Plan Commission

Monday, December 21, 2020

SUBJECT: Consideration and possible action on a request for a site plan to add 71,255 SF to an existing building at 1800-1862 Commerce DR (Parcels ED-344-101-1, ED-344-101-5).

Staff recommends APPROVAL of the site plan request for a new 71,255 SF industrial building addition at 1800-1862 Commerce DR, subject to compliance with the conditions listed in the 'Staff Comments' section of this report.

DRAWN	LP	CHKD	PHK
DATE	11/11/2020	SCALE	AS NOTED
DRAWING NO.	C101		
PROJECT NO.	3439013	REV.	XX

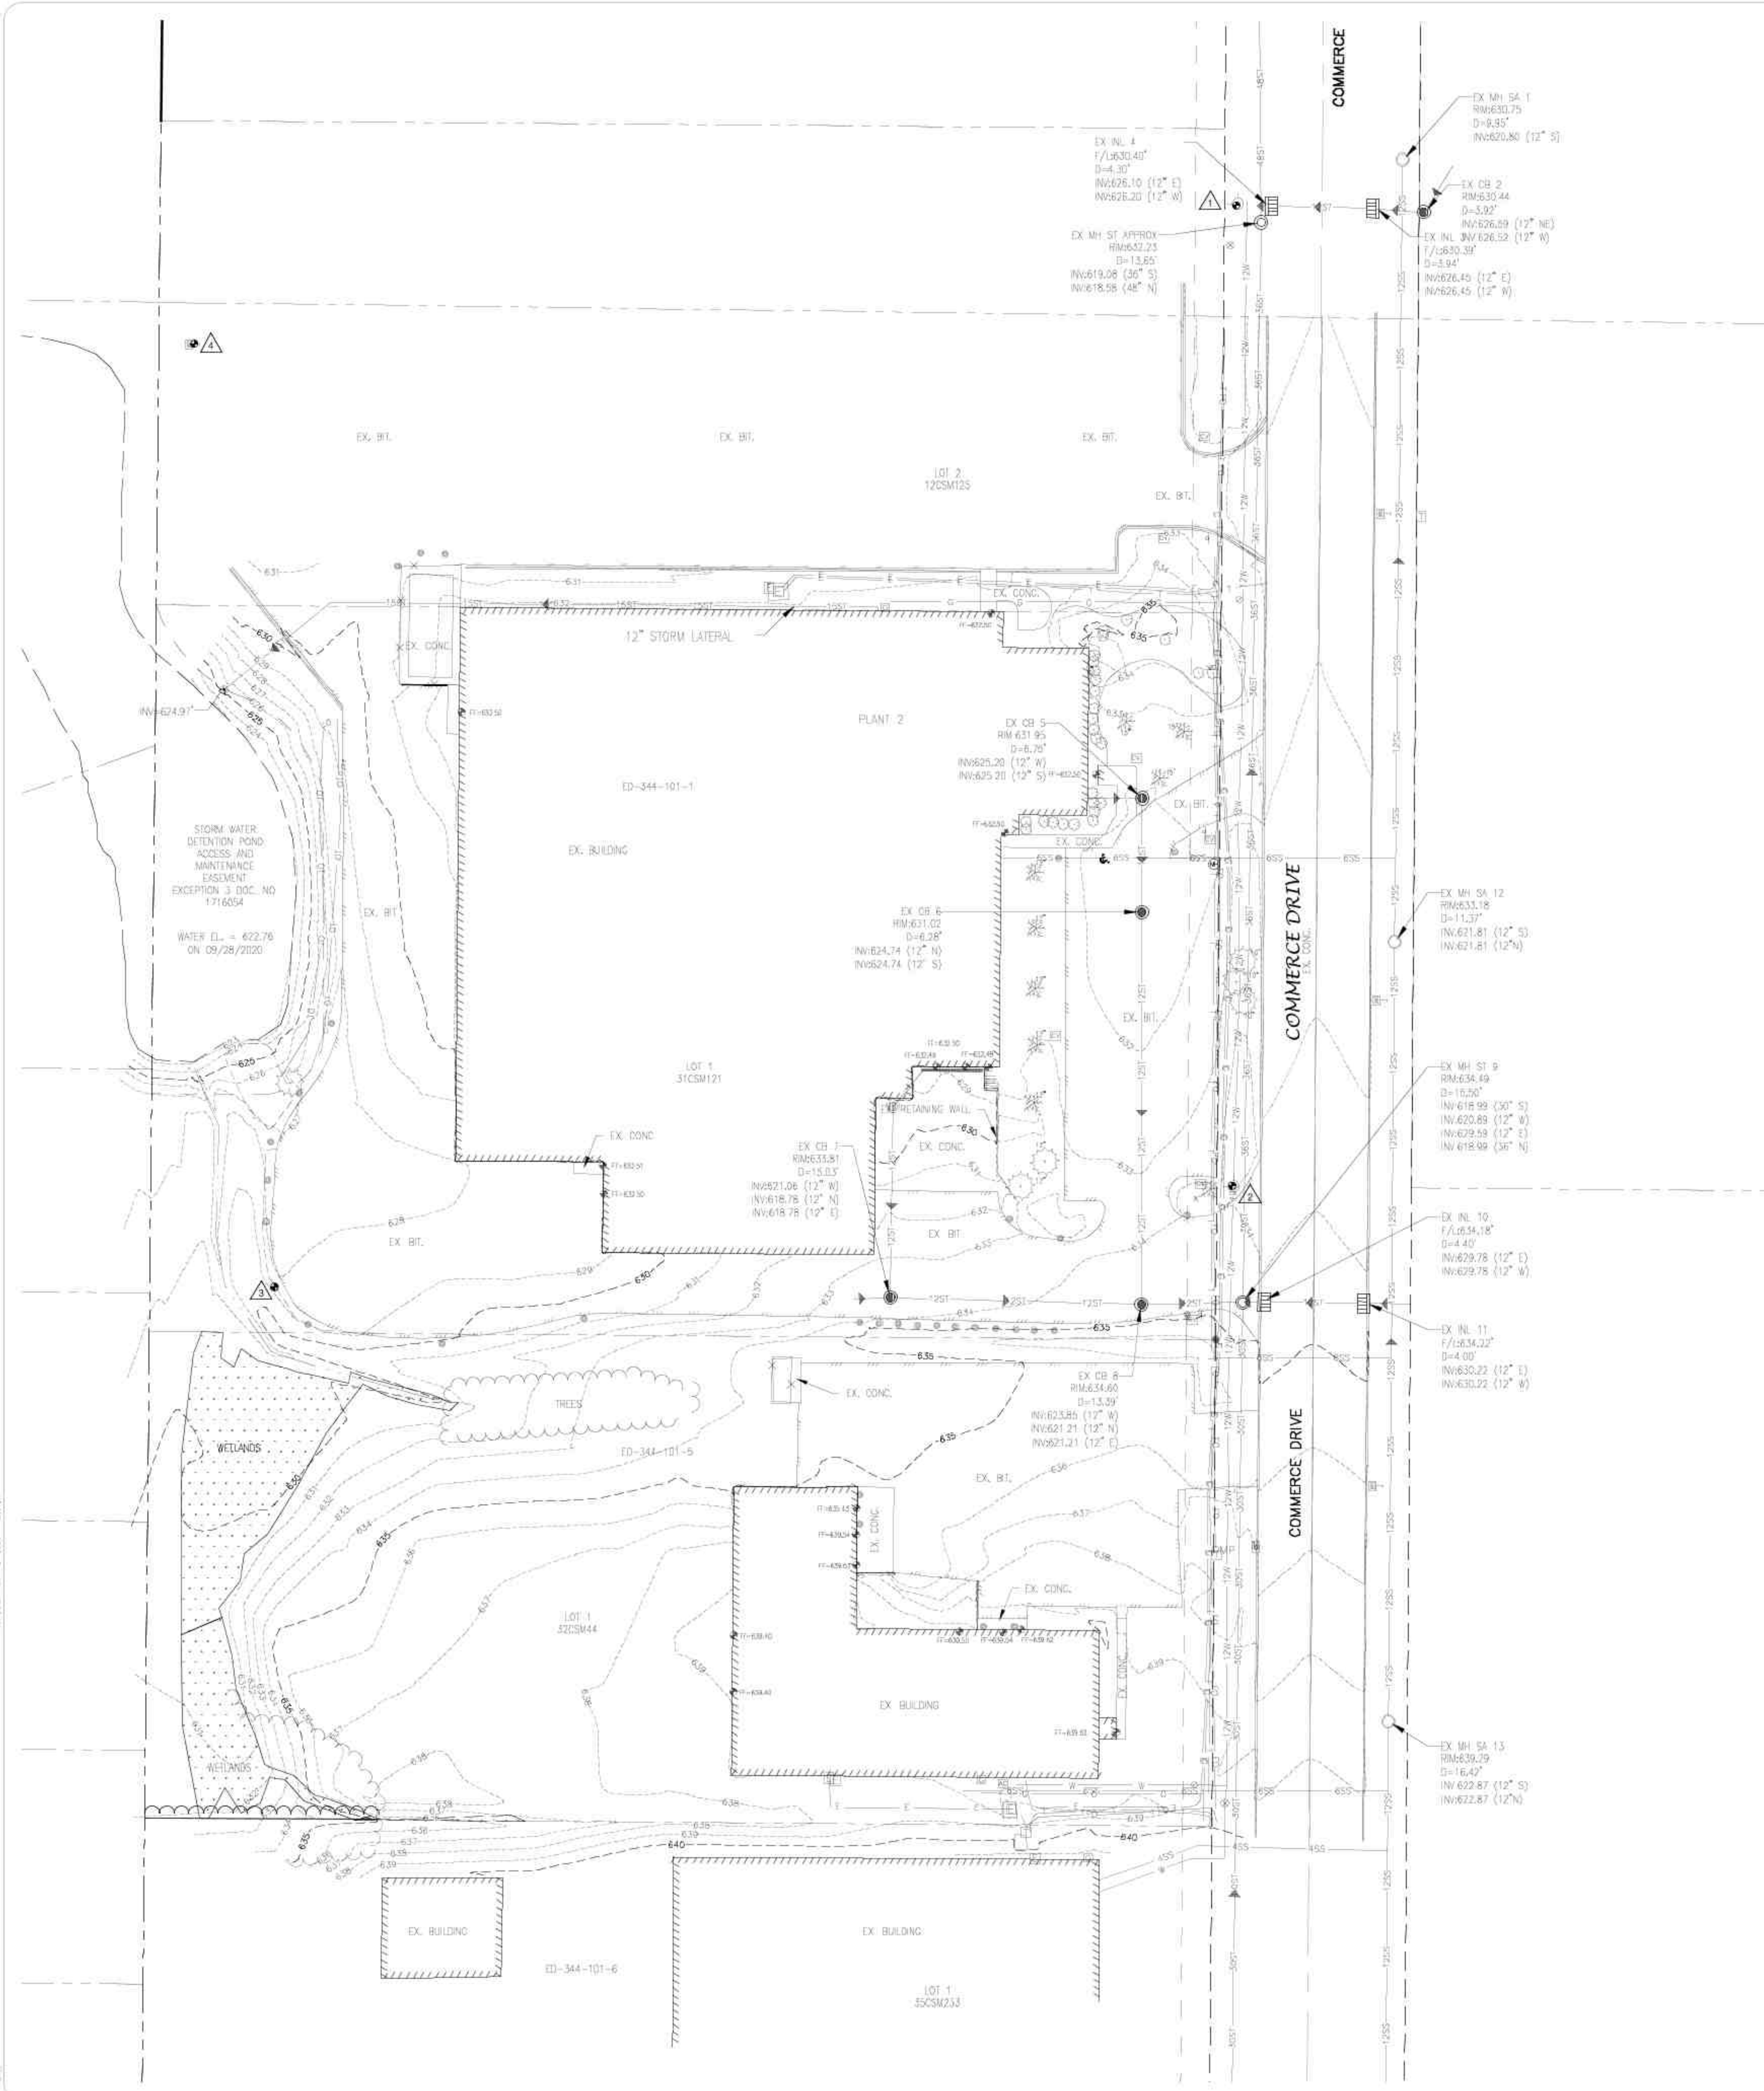
2. Sheet C100
 - a. Provide site address.
3. Sheet C101
 - a. Label existing utility easement along Commerce Drive.
 - b. The existing utility information is illegible.

FILE	LP	CHKD	PHK
DATE	11/11/2020	SCALE	AS NOTED
DRAWING NO.	C102		
PROJECT NO.	3439013	REV.	XX

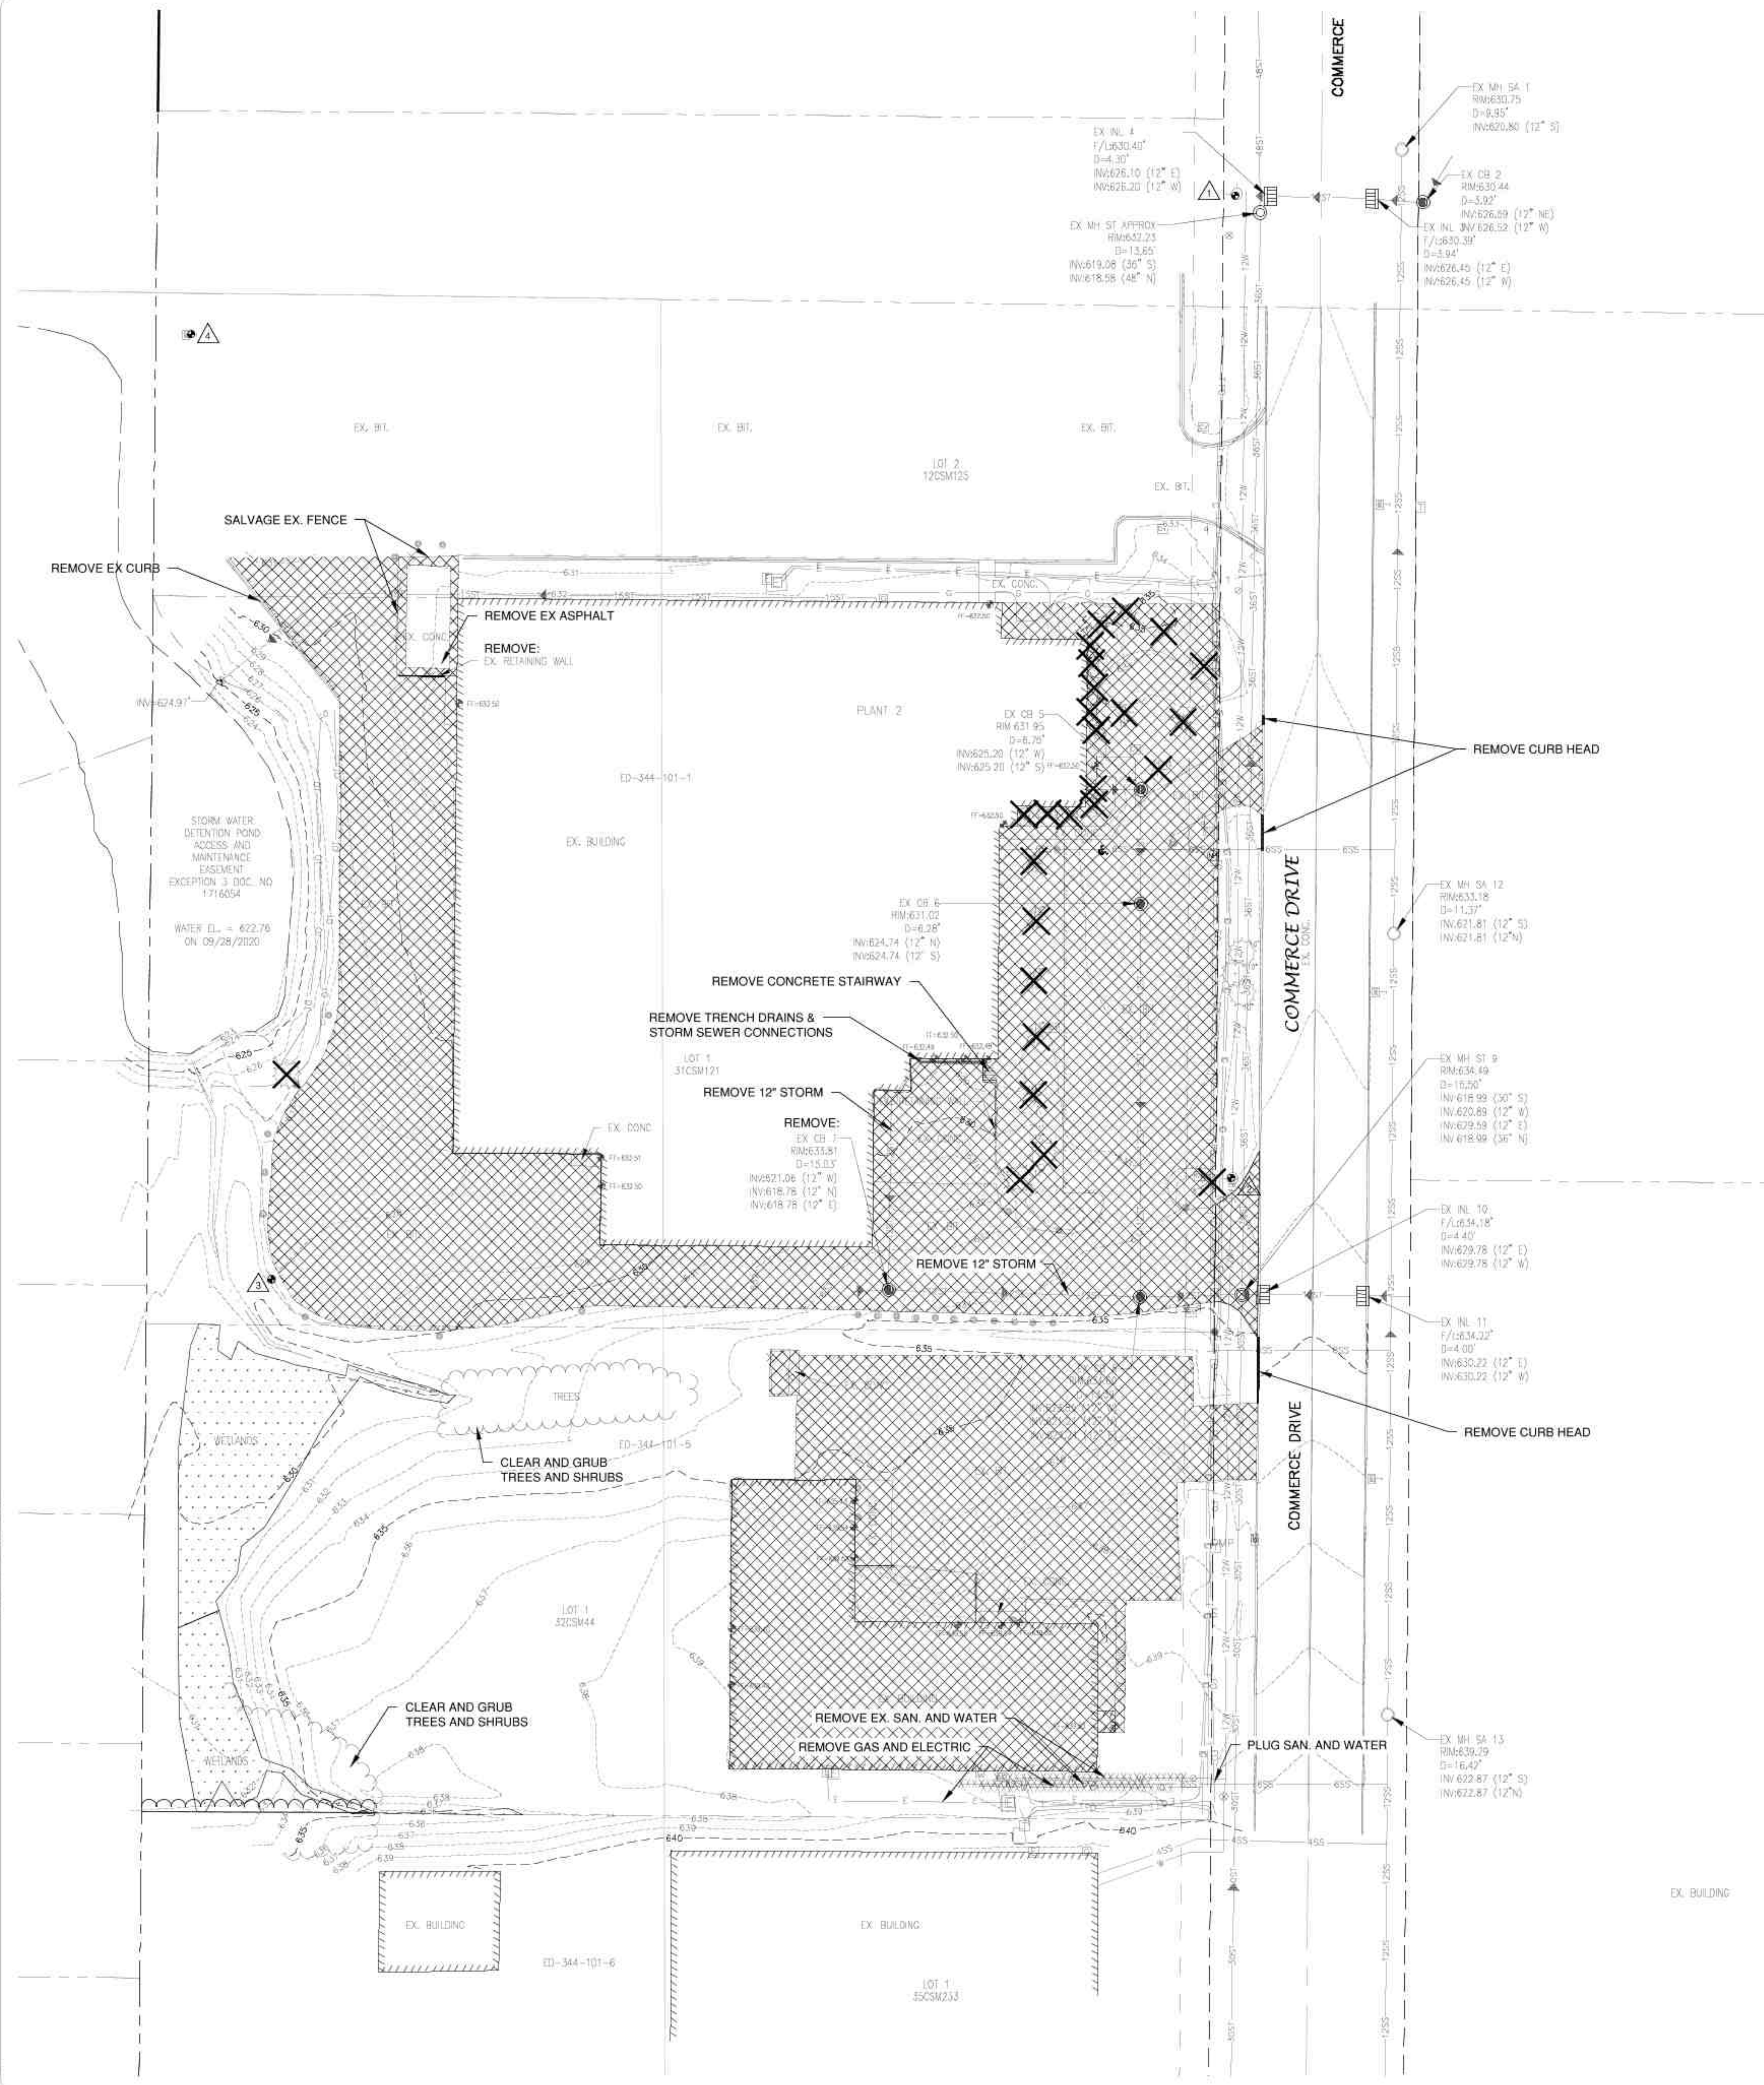
4. Sheet C102
 - a. Label existing utility easement along Commerce Drive.
 - b. The existing utility information is illegible.
 - c. Provide note stating that the curb head removal shall be completed by a licensed concrete worker with the City of De Pere via a hydraulic, mounted, profile cut saw. Breaking off the curb head at the flow line will not be permitted and will result in further concrete replacement. A concrete worker's license can be obtained through De Pere Public Works at 920-339-4061.

- d. Provide property line information with northing/easting along the property line.
 - e. The existing water service that is being removed will need to be abandoned at the main. No size information is provided, but either the Tee or corporation will need to be removed. Repairs should then be completed using stainless steel solid sleeve repair bands.

- f. No curb removal detail provided as indicated in demolition note #4.
5. Sheet C103
 - a. The driveway/access aisle from the northern driveway apron is too narrow. The City of De Pere Municipal Code requires that a 24-foot wide aisle be provided. If this is infeasible, the driveway shall be marked as one way. To aide in accommodating this extra width, the parking stalls can be shortened from 20 foot long to 18 foot long at the shortest.
